ADDENDUM #1

IU 20240652 IN031 Coleman Hall Replaced Failed Transformer

Mussett, Nicholas & Associates, Inc.
502 S. West St
Indianapolis, IN 46225
MNA Commission No.: 2025263

TO ALL HOLDERS OF PROCUREMENT DOCUMENTS

3/06/2026 12:17:20 PM G:\Shared\Projects\2025263\3 - Design\3.05 - Drawing Files\3.05.1 - Working Drawings\E701.dwg

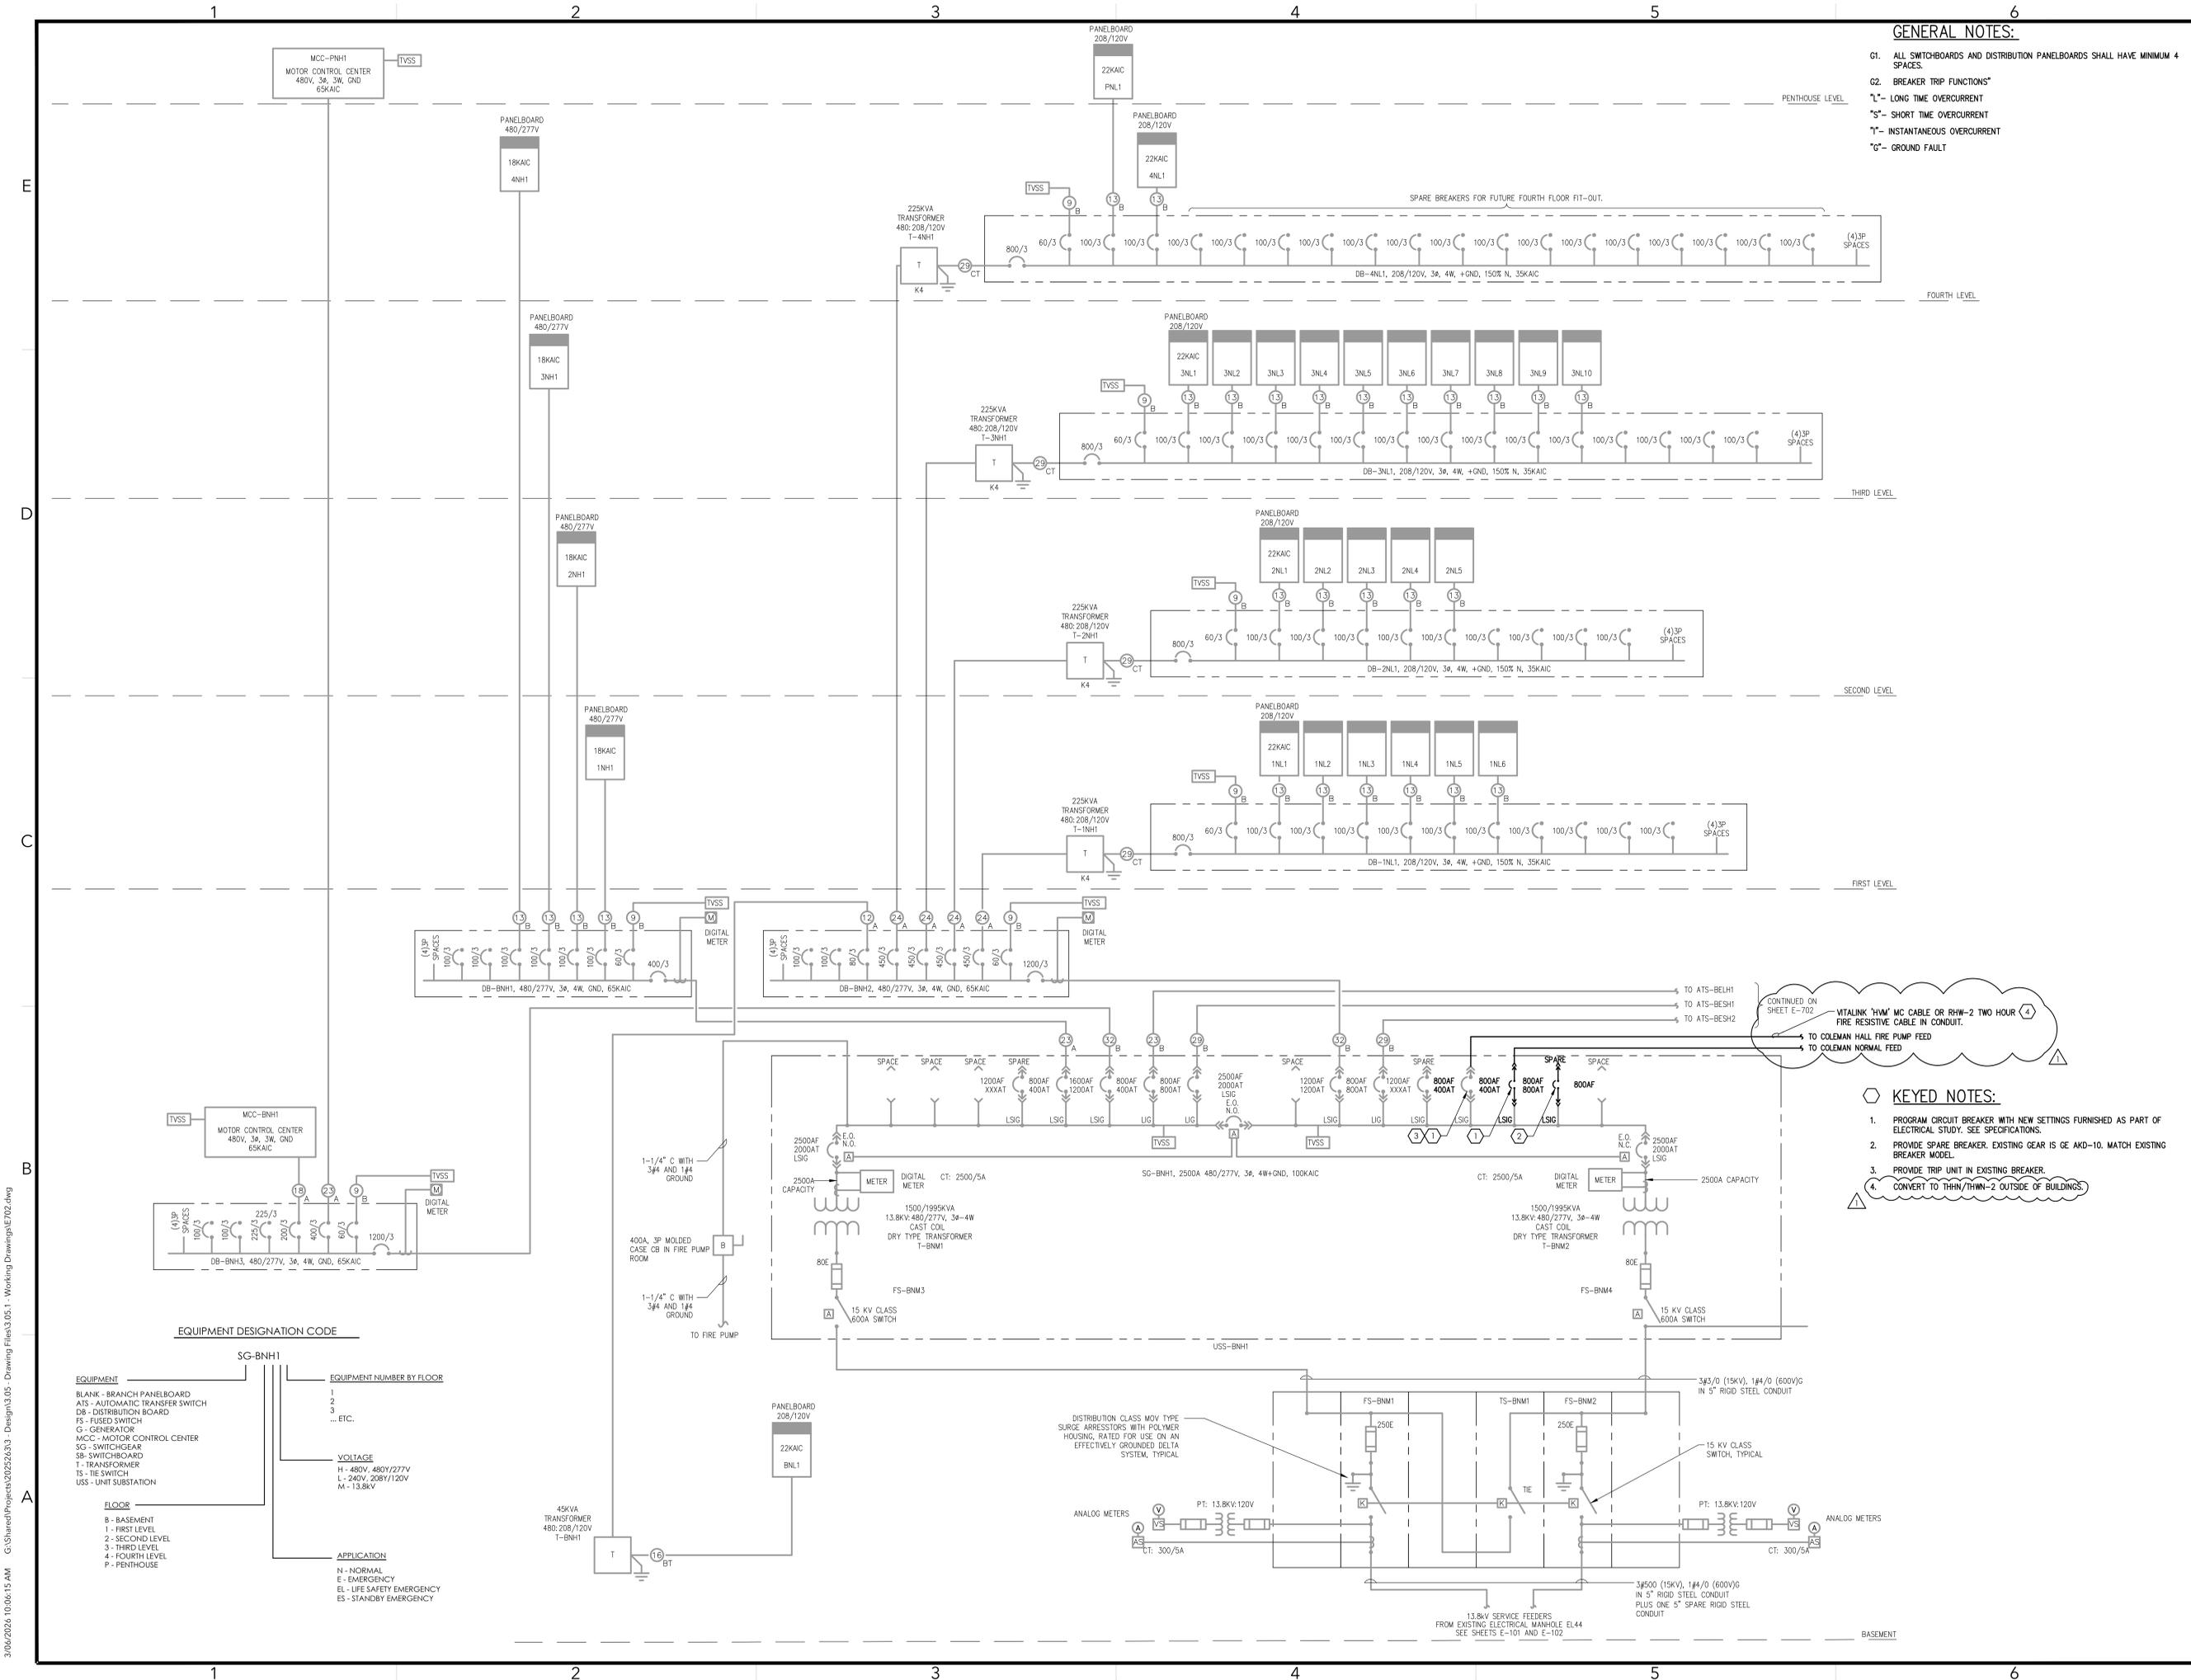
- a) Yes this is an acceptable alternative.
- 9) Is the feeder to the BN-MCC by note 1 on E701 based bid or alternate #3?
 - a) This will be part of the alternate for the MCC.

- E701 - Fire pump feeder size was changed downstream of the 200A disconnect. Keyed note was added to clarify a feeder being THHN/THWN-2 outside of the building. Other keyed notes were updated for fire pump clarification.

1. PROGRAM CIRCUIT BREAKER WITH NEW SETTINGS FURNISHED AS PART OF ELECTRICAL STUDY. SEE SPECIFICATIONS.
2. PROVIDE SPARE BREAKER. EXISTING GEAR IS GE AKD-10. MATCH EXISTING BREAKER MODEL.
3. PROVIDE TRIP UNIT IN EXISTING BREAKER.
4. CONVERT TO THHN/THWN-2 OUTSIDE OF BUILDINGS.
